# SERVICE BULLETIN

## USE OF THE ROTAX® SUPPLIED AIRBOX FOR ALL ROTAX® ENGINE TYPES 912 UL (SERIES) SB-912-044UL R1

# SERVICE BULLETIN

## USE OF THE ROTAX® SUPPLIED AIRBOX FOR ALL ROTAX® ENGINE TYPES 912 A/F (SERIES) SB-912-044 R1

**Fig. 1**  
**carburetor**

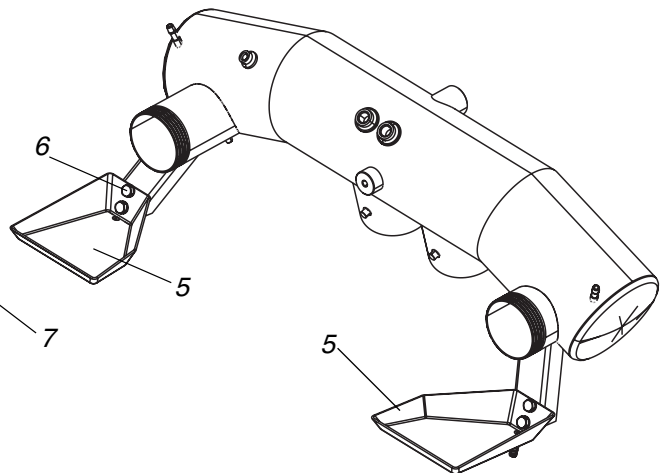
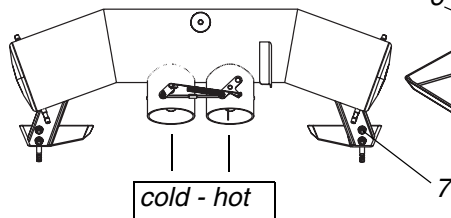
See fig. 1.

1. Check the existing main jet of carburetors 1/3 and 2/4, depending on the model of the installed airbox change if necessary the main jet (1) (see table section 3.3) according to the latest Maintenance Manual.
2. Set the position of the jet needle (2) of the carburetors 1/3 and 2/4 to position 3 according to the latest Maintenance Manual.

■ **CAUTION:** The jet needle position described above is the basic adjustment for the airbox part no. 867756 and airbox part no. 667355.

**fig. 2**  
**airboxes**

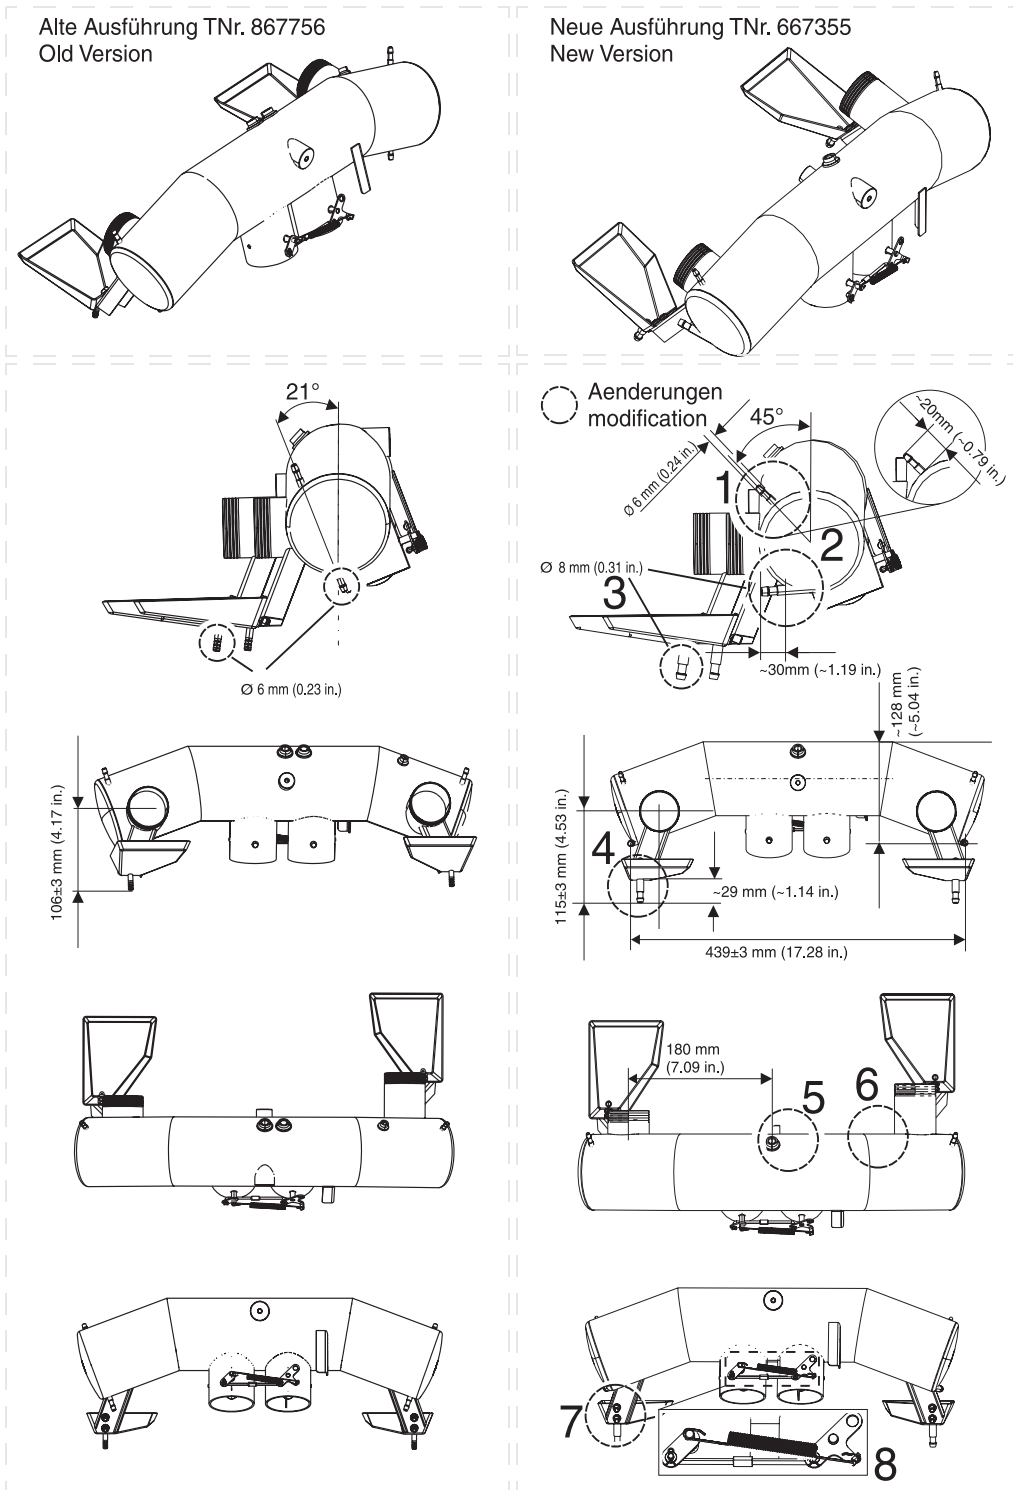
See fig. 2

◆ **NOTE:** The airbox has been pre-assembled as much as possible.  
(see fig. 2 and fig. 3, drawing shows asymmetrical drip trays)

1. Attach the two symmetrical drip trays (5) to the drip tray holder with hex. screws M5x12 (6) and washer and nut M5 (7).

1. Put pre-assembled airbox (4) in position with the connection tubes (8) and 2 hose clamps (9) each as far they go on the connections of the carburetor (10). Afterwards adjust airbox such that it is positioned parallel to the engine suspension frame/ignition housing and is level.

◆ **NOTE:** Make sure that the air connections of the airbox are correctly connected for fresh air and pre-heated air (see fig. 2).
